Access Audit Site Report

Government Canyon State Natural Area

Accessibility Evaluation

Inspection Date: 03/22/2022

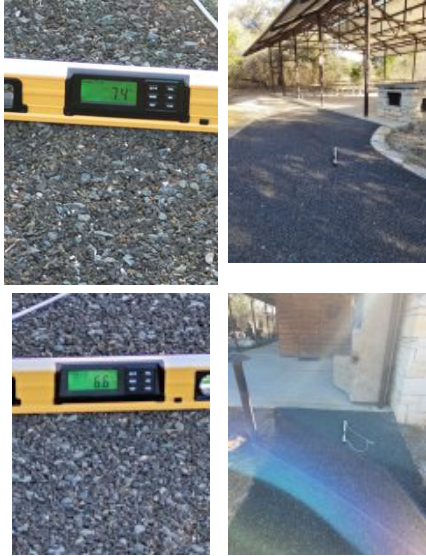
Finding Number	Area Description	Lat/Long	Finding	As Built	Recommendation	Citation	Photos	Figure
4	Headquarters Area: HQ - Parking Lot A and Exterior Accessible Route	[29.5490838, -98.7647127], [29.5485773, -98.7646188]	The running slope of walking surfaces shall not be steeper than 1:20.	From lot A right path to visitor center - 6.7%, 7.2% running slopes	Correct running slope along the AR to max 5%	2015 ABAAS Section: 403.3 2012 TAS Section: 403.3 2010 ADAS Section: 403.3		
5	Headquarters Area: HQ - Parking Lot A and Exterior Accessible Route	[29.5488555, -98.7648138], [29.5491062, -98.7647119]	There is a gap spaced greater than a 1/2 inch. Openings in floor or ground surfaces shall not allow passage of a sphere more than 1/2 inch diameter. Elongated openings shall be placed so that the long dimension is perpendicular to the dominant direction of travel.	From lot A, left path - 2", 1.25" gaps	Correct or fill gaps to be max .5".	2015 ABAAS Section: 302.3 2012 TAS Section: 302.3 2010 ADAS Section: 302.3

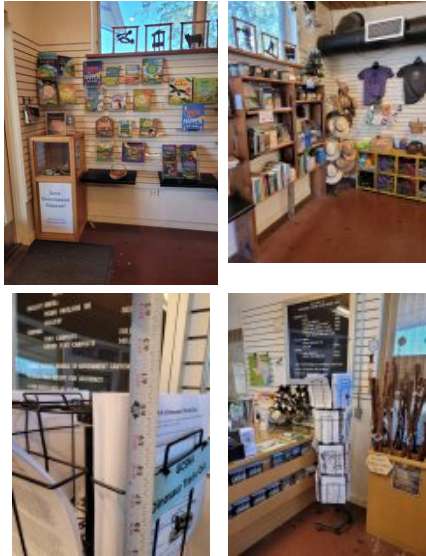
11	Headquarters Area: HQ - Group Picnic Pavilion	[29.5486751 , -98.7657621]	The cross slope shall not be steeper than 1:48. EXCEPTION: Where the surface is other than concrete, asphalt, or boards, cross slopes not steeper than 1:20 shall be permitted when necessary for drainage.	Picnic sites to the left approaching pavilion - 5.9% right side, loose gravel, but mostly level; BBQ surface is compliant; 2 of 2 sites with picnic tables with wheelchair space	Correct or repair ORAR cross slope to max 5% for surfaces other than concrete, asphalt or board as a smart practice.	2015 ABAAS Section: 1016.7.2, 1016.7.2 EXCEPTION

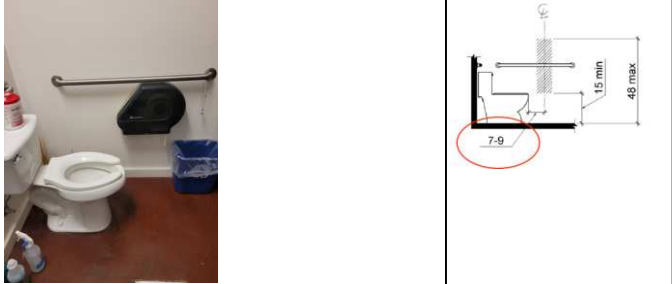
29	Headquarters Area: HQ - Men's Restroom	[29.5493092 , -98.764859 2]	The accessible route contains running slopes greater than 5 percent and cross slopes greater than 2 percent across the width of the walk and has not been constructed as a ramp (i.e. handrails, wheel guides, etc.). When the slope in the direction of travel of any walk exceeds 1 unit vertical in 20 units horizontal (5-percent slope), it must be constructed as ramp. Surface cross slopes must not exceed one unit vertical in 48 units. Horizontal (2-percent slope).	2.8% near drain at sink	Correct or repair slope to max 2.08% in restroom.	2015 ABAAS Section: 403.3 2012 TAS Section: 403.3 2010 ADAS Section: 403.3

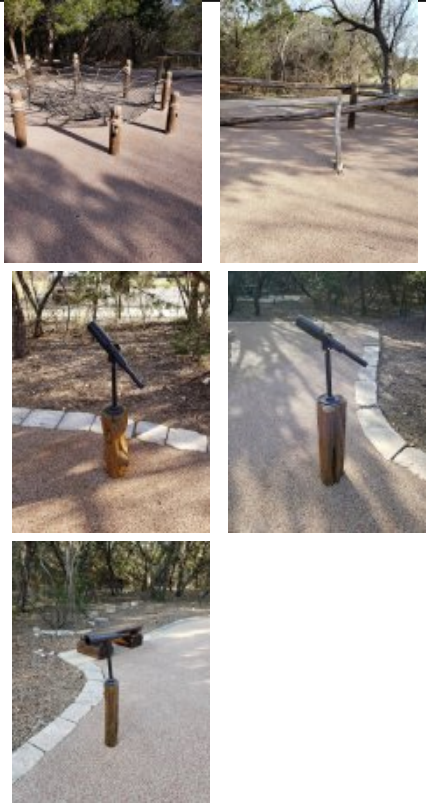
44	Day Use Area: Day Use - Parking Lot C and Exterior Accessible Route	[29.5486517 , -98.75966 64], [29.5486434 , -98.758979 8]	The cross slopes (narrow dimension) and/or running slopes (long dimension) of the access aisle exceeds 2%. The running slope and the cross slope in an accessible parking stall and the access aisle must not exceed 2%.	Stalls near picnic area and playground - left access aisle - 3.5%; middle stall 5.9%, access aisle 3.1%; CXT restroom - stall 3.5%, access aisle 3.4%	Repair or correct slope of parking space and access aisle to max 2.08% in any direction.	2015 ABAAS Section: 502.4 2012 TAS Section: 502.4 2010 ADAS Section: 502.4

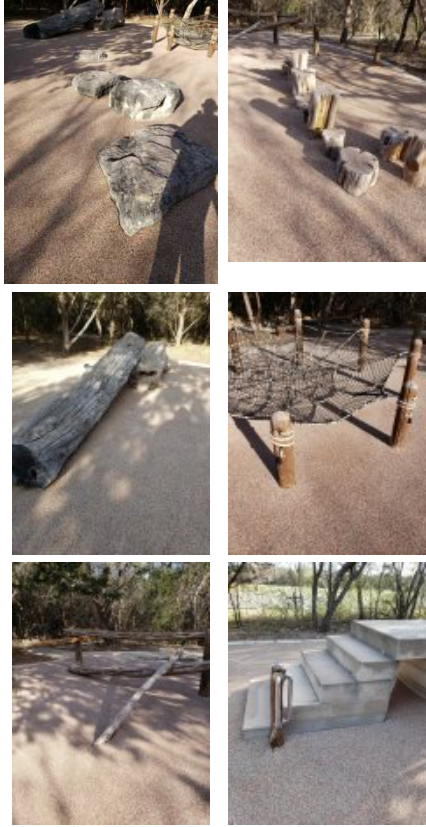
Finding Number	Area Description	Lat/Long	Finding	As Built	Recommendation	Citation	Photos	Figure
45	Day Use Area: Day Use - Parking Lot C and Exterior Accessible Route	[29.5487623 , -98.75893 82], [29.5487462 , -98.759667 8]	The parking stall contains abrupt edges and surface irregularities over a 1/4 inch vertical. Parking spaces and access aisles serving them shall be stable, firm, and slip resistant. Access aisles shall be at the same level as the parking spaces they serve. Changes in level are not permitted and shall not be sloped steeper than 2% in any direction.	7.75" and 8" gaps at restroom, 1" gap middle stall at play area	Repair, bevel and ramp CIL and gaps in stalls and access aisles	2015 ABAAS Section: 502.4 2012 TAS Section: 502.4 2010 ADAS Section: 502.4		
46	Day Use Area: Day Use - Parking Lot C and Exterior Accessible Route	[29.5486802 , -98.758913 7]	The accessible route of travel contains cross slopes greater than 2%. Cross slopes shall not exceed one unit vertical in 48 units horizontal (2-percent slope).	From parking to restroom - 2.6% cross	Correct or repair cross slope along AR to max 2.08%.	2015 ABAAS Section: 403.3 2012 TAS Section: 403.3 2010 ADAS Section: 403.3

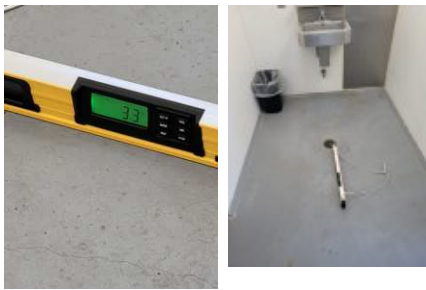
Finding Number	Area Description	Lat/Long	Finding	As Built	Recommendation	Citation	Photos	Figure
56	Day Use Area: Day Use - Men's Restroom	[29.5486105 , -98.758899 3]	Knee clearance at 27 inches off the floor is not 8 inches minimum deep. The knee clearance, measured from the bottom of the apron or the outside bottom edge of the lavatory, must be 27 inches at a point located 8 inches back from the front edge and continuing to 11 inches minimum in depth at 9 inches above the floor. The top of the lavatory rim may be no higher than 34 inches.	7.25" knee clearance depth	Remove pipe cover to provide 8" deep knee clearance	2015 ABAAS Section: 306.3.1, 306.3.2, 306.3.3, 306.3.4 , 306.3.5 2012 TAS Section: 306.3.2, 306.3.3, 306.3.4, 306.3.5, 306.3.1 2010 ADAS Section: 306.3.3, 306.3.2, 306.3.4, 306.3.5, 306.3.1		
57	Day Use Area: Day Use - Men's Restroom	[29.5486045 , -98.758899 3]	The stall door fails to comply with all of the door requirements. The stall door must be self-closing.	Stall door not self-closing	Adjust stall door to be self-closing	2015 ABAAS Section: 404.2.3, 404.2.7, 604.8.2.2 2012 TAS Section: 404.2.3, 404.2.7, 604.8.2.2 2010 ADAS Section: 404.2.3, 404.2.7, 604.8.2.2

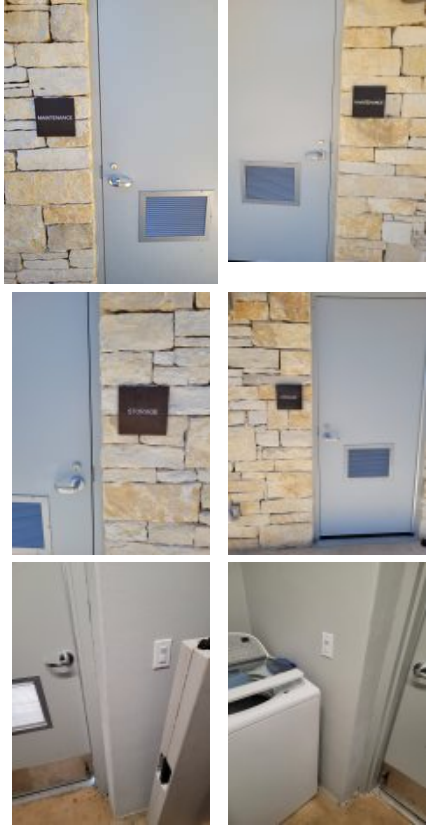
67	Back Country Trails: Back Country Trails	[29.5545622 , -98.754559 5]	The surface of trails, passing spaces, and resting intervals shall be firm and stable	back country trails not accessible surface, all rated moderate to challenging by TPWD	Leave as is back country trails and designate one of the front country trails at this site accessible	2015 ABAAS Section: 1017.2		
68	Back Country Trails: Back Country Primitive Toilet	[29.5889399 , -98.757641 4]	An accessible access route is not provided between elements, spaces and the facilities provided within the accessible camping unit. At least one outdoor recreation access route shall connect accessible elements, spaces and facilities provided within camping units with mobility features.	Backcountry toilet - 4 mile hike to location; non accessible toilet with stair only access and no accessible features	Replace or add toilet along backcountry trails that is accessible and connect to an accessible trail	2015 ABAAS Section: F244.5.1

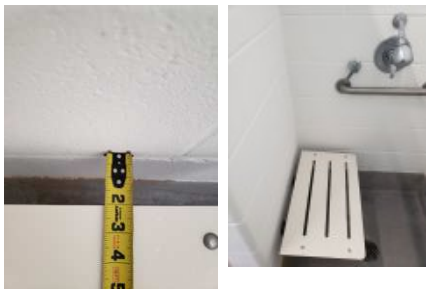
123	Camping Area: Camping - Shower Rooms	[29.5505402 , -98.755975 7]	The self closing faucet controls do not stay open for a minimum of 10 seconds. Faucet controls and operating mechanisms shall be operable with one hand and shall not require tight grasping, pinching or twisting of the wrist. The force required to activate controls shall be no greater than 5 lb. Lever-operated, push-type and electronically controlled mechanisms are examples of acceptable designs. Self-closing valves are allowed if the faucet remains open for at least 10 seconds.	Family Shower Room - Unable to test	Water shut off - unable to test. Assure sink faucets remain on for min. 10 seconds when reopened.	2015 ABAAS Section: 606.4 2012 TAS Section: 606.4 2010 ADAS Section: 606.4
